RE: Blythe Energy Transmission Line Project Request for Approval of Insignificant Change (99-AFC-8C)

**Request for Approval of Second
Insignificant Project Change
(99-AFC-8C)**

**Blythe Energy Project
Transmission Line
Minor Route Realignment and
Change in Laydown Yards**

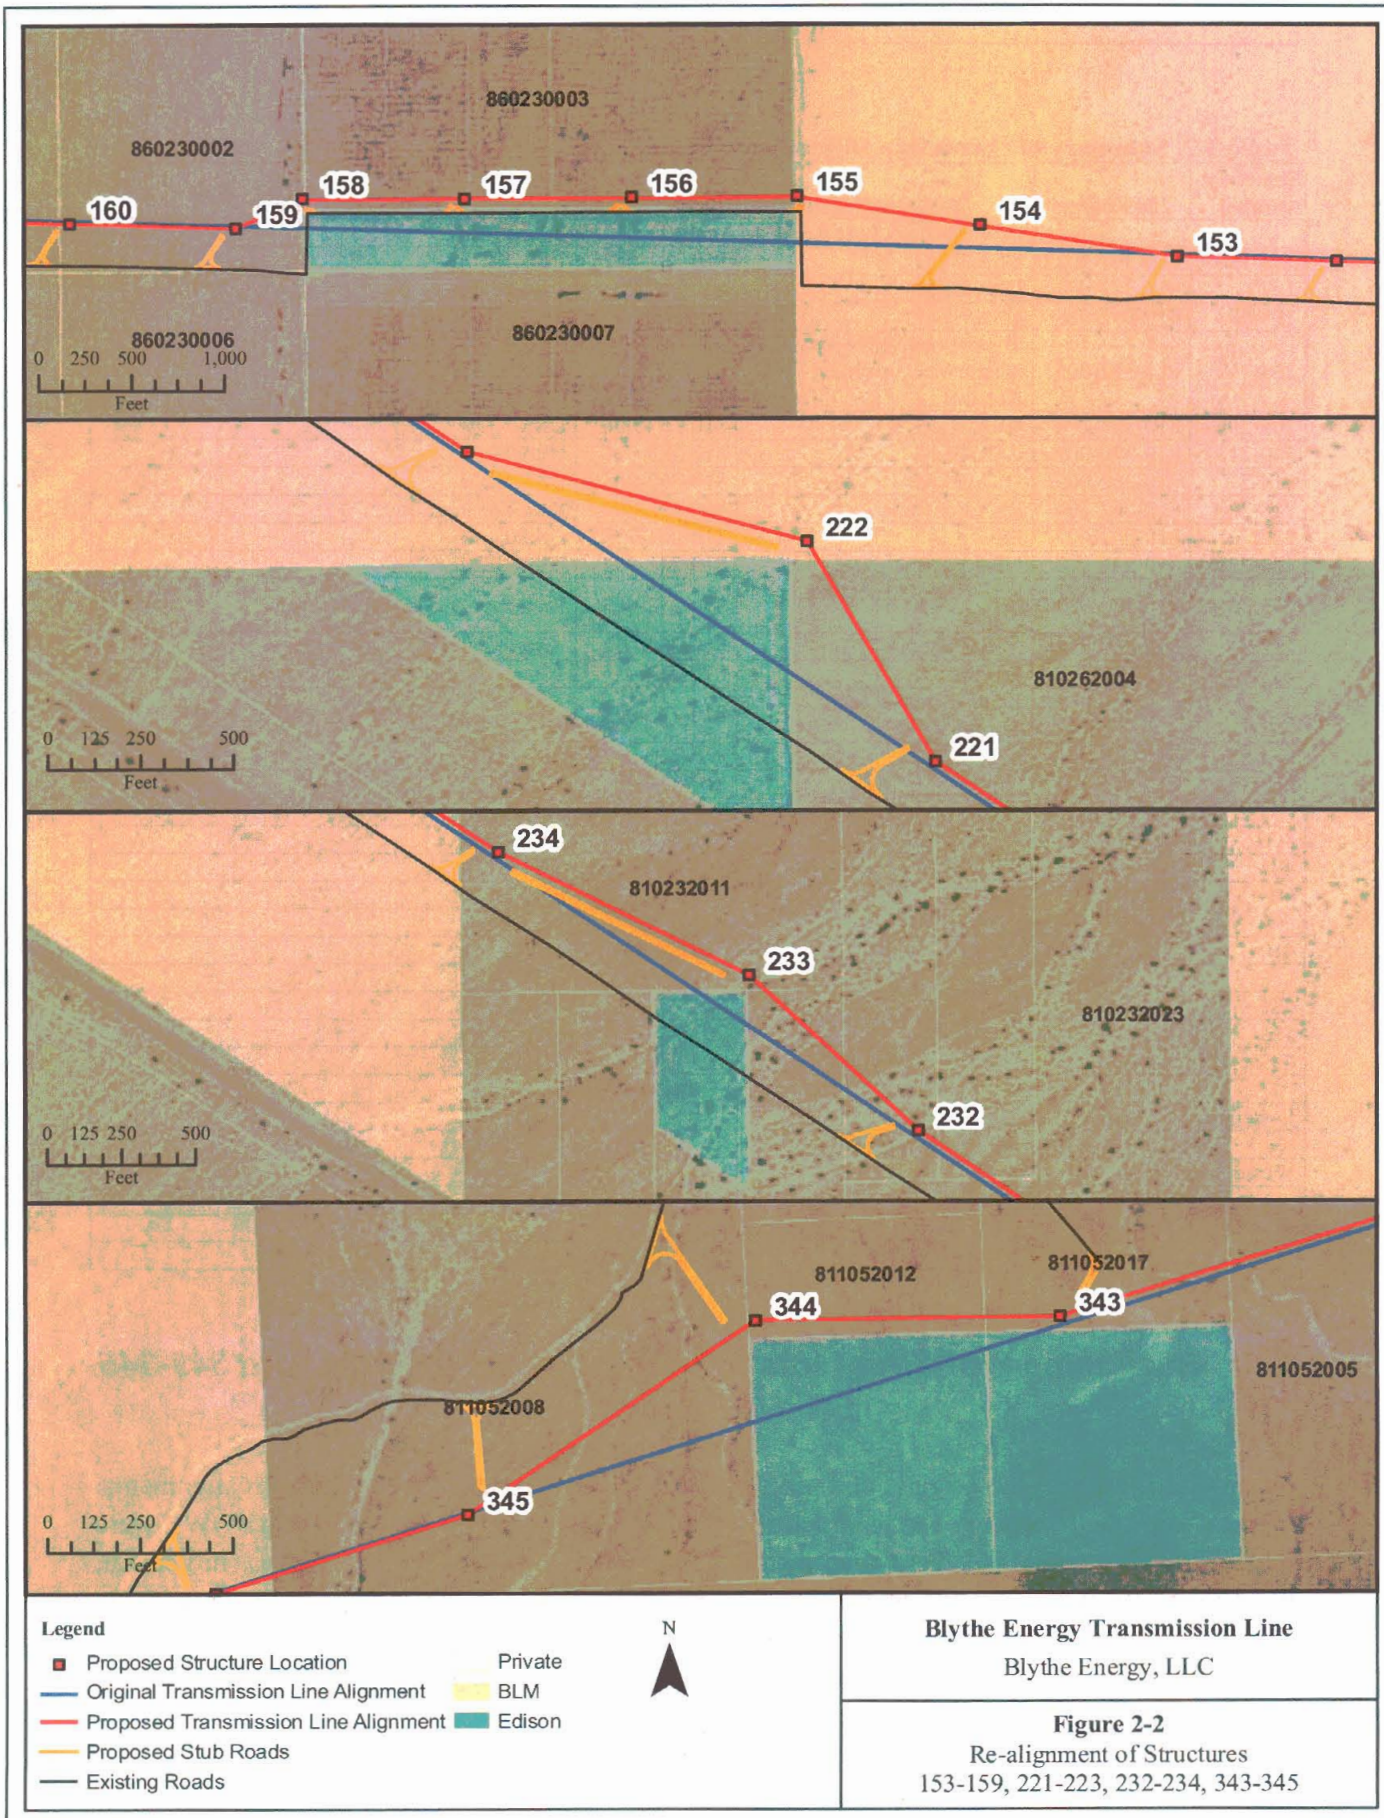
Figure 2-2 illustrates the original and proposed realignment for each of these four realignments. In each case, the centerline of the structures, and the accompanying right-of-way (ROW), were moved to avoid parcels of fee-owned land by Southern California Edison (Edison). In general, the alignments were adjusted to the north or northeast to avoid placing any structures in the Edison fee parcels. There is a very small change (0.02 acre) in disturbance footprint due to slight changes in access roads to accommodate these minor structure realignments.

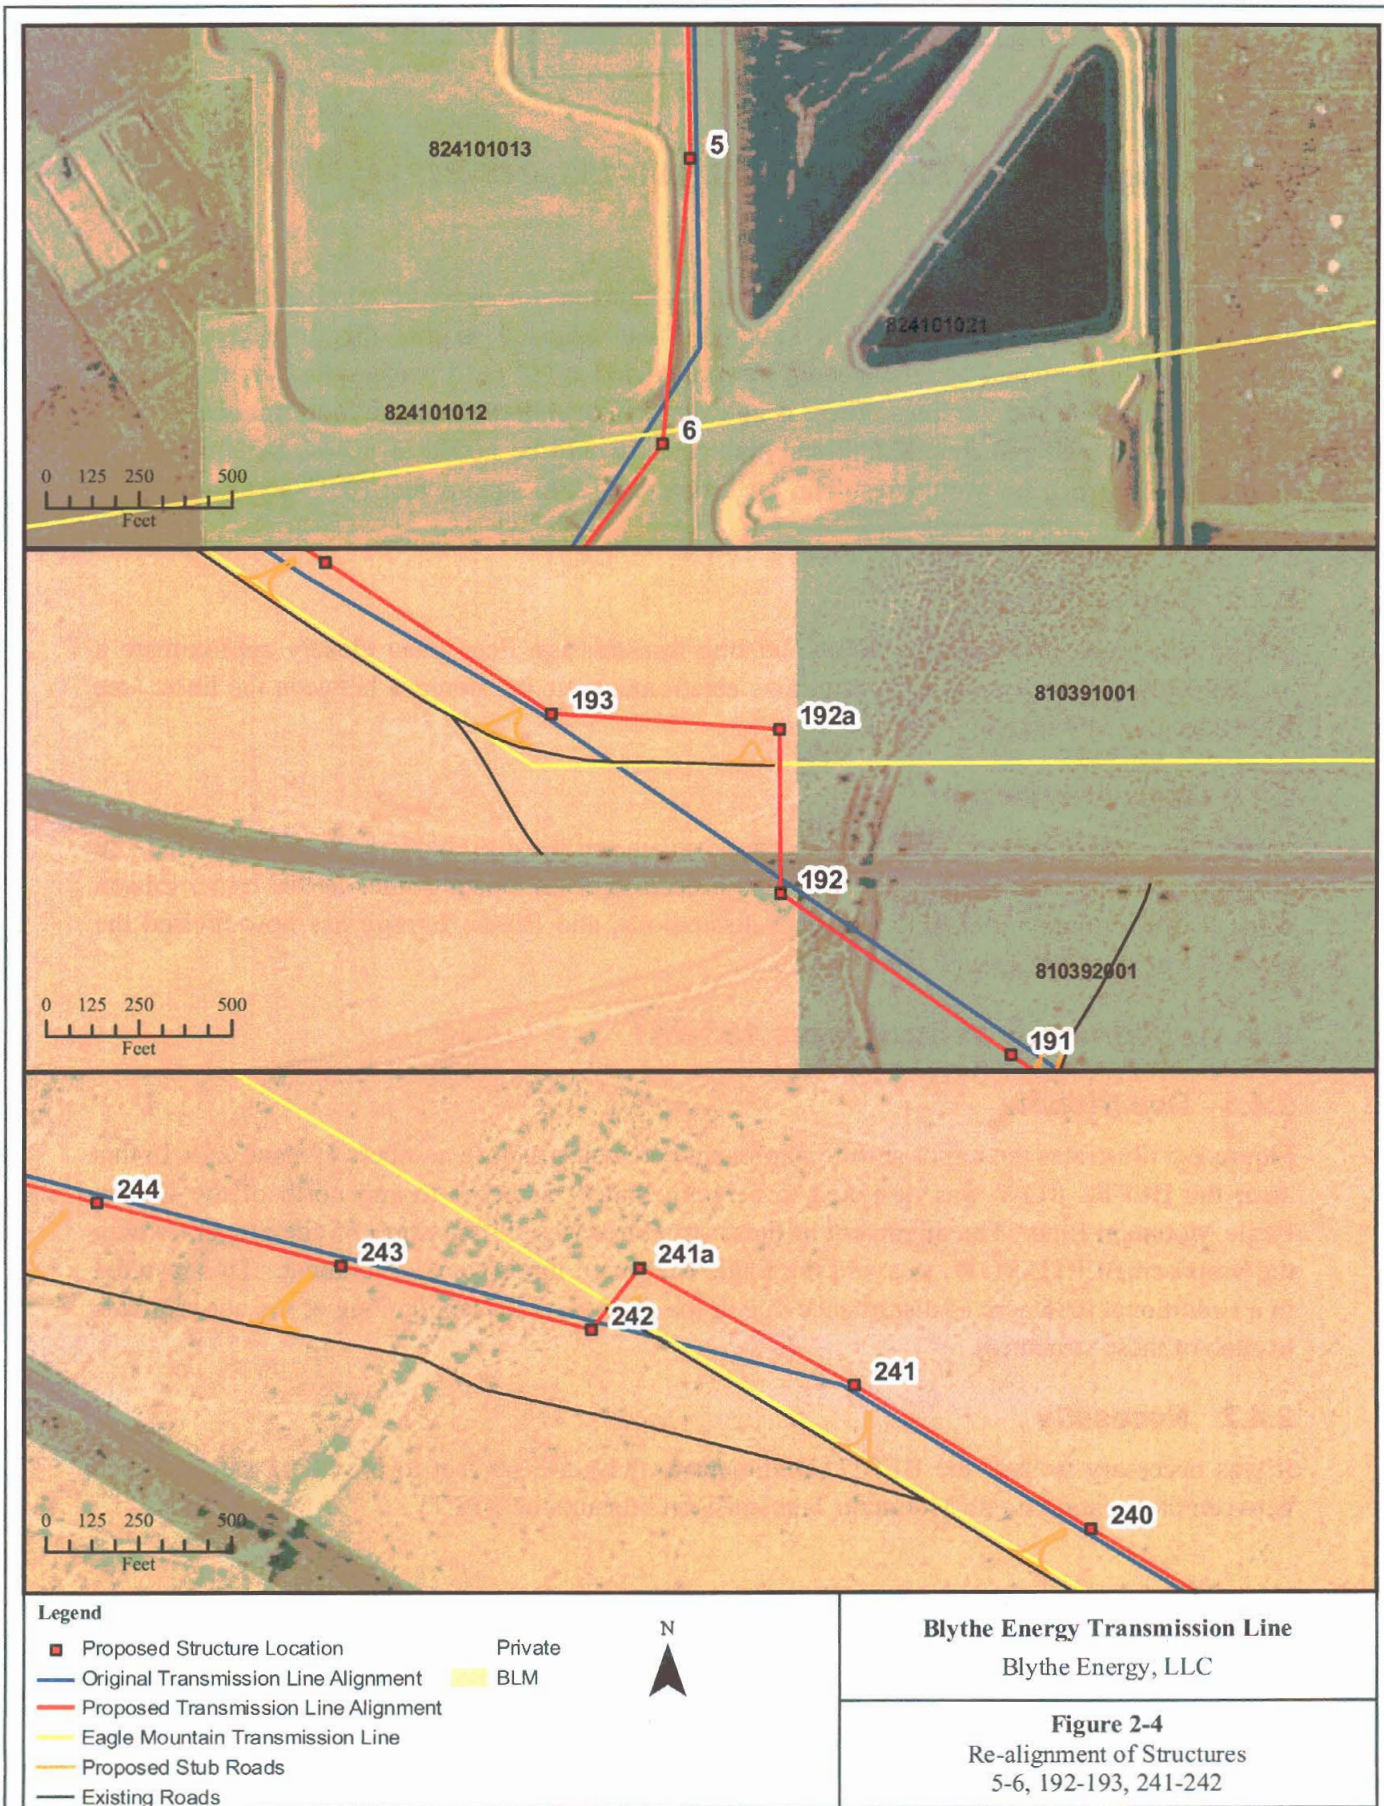
Figure 2-4 illustrates the original and proposed realignment for structure numbers 5-6, 192-193, and 241-242. Each of these pairs of structures was adjusted so that the three crossings of transmission lines owned by others could be constructed at $90^\circ (\pm 15^\circ)$ as required by the owners of the existing transmission lines. There is no change in overall disturbance footprint due to these minor structure realignments. Additional stub roads would be added to access structures 192a and 241a. The revision would result in an estimated 1,200 square feet (0.03 acre) additional disturbance from access roads.

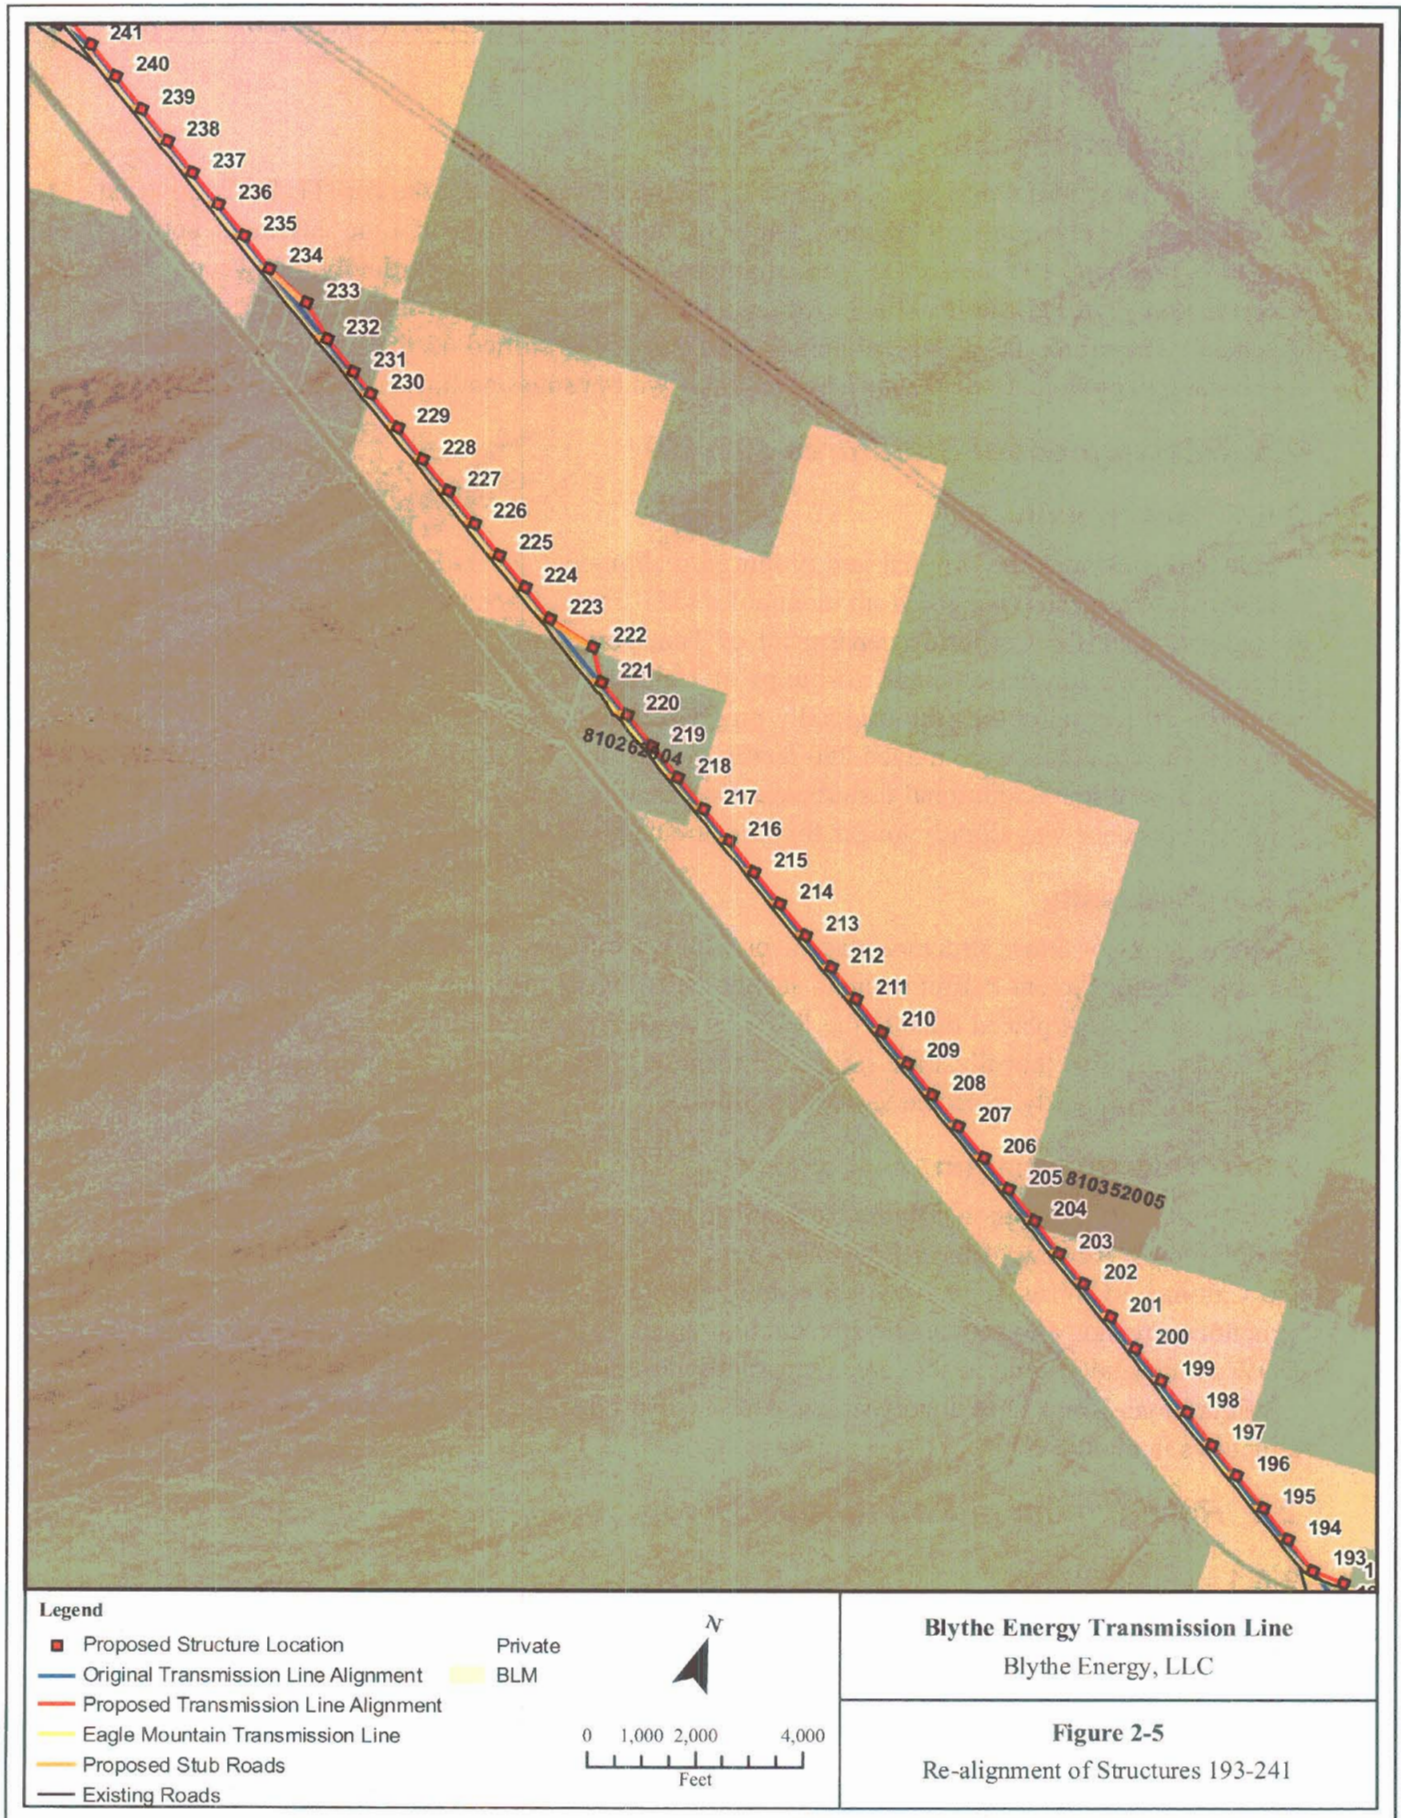
Figure 2-5 illustrates the minor shift in alignment between structure numbers 193 and 241. In this area, the BEPTL ROW was designed to be immediately adjacent to and north of the Edison Eagle Mountain Line. The alignment of these structures was shifted north 65 feet, together with the proposed BEPTL ROW, to avoid the Eagle Mountain line's actual alignment. This resulted in an additional 0.86 acre of disturbance due to the needed minor lengthening of the access roads to each of these structures.

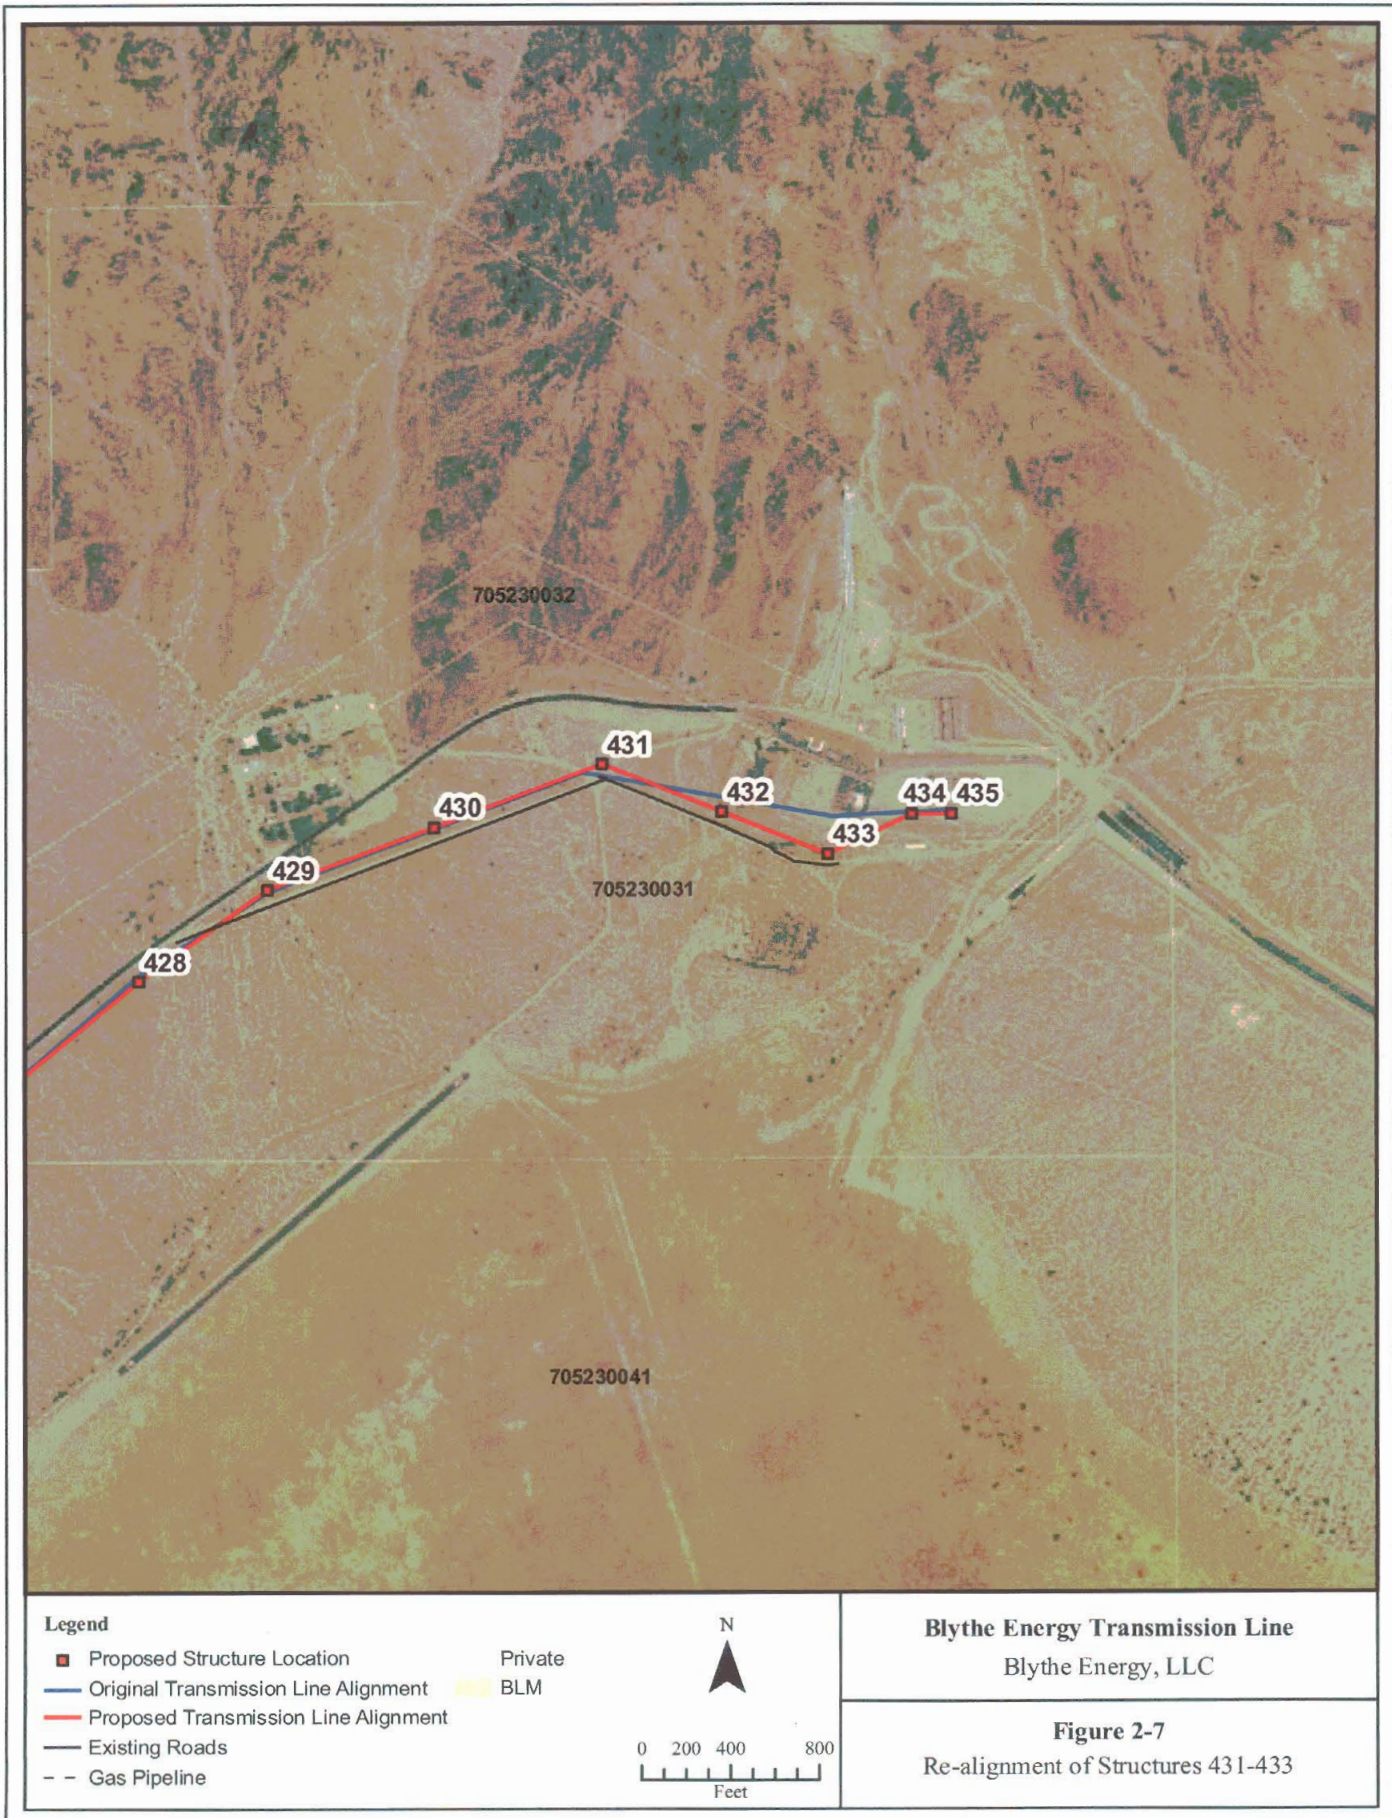
Figure 2-7 illustrates the original and proposed realignment for structure numbers 431-433. These structures were moved south to avoid a propane fuel area. The structures are closer to an existing access road and will not require stub roads, reducing the disturbance by 0.1 acre.
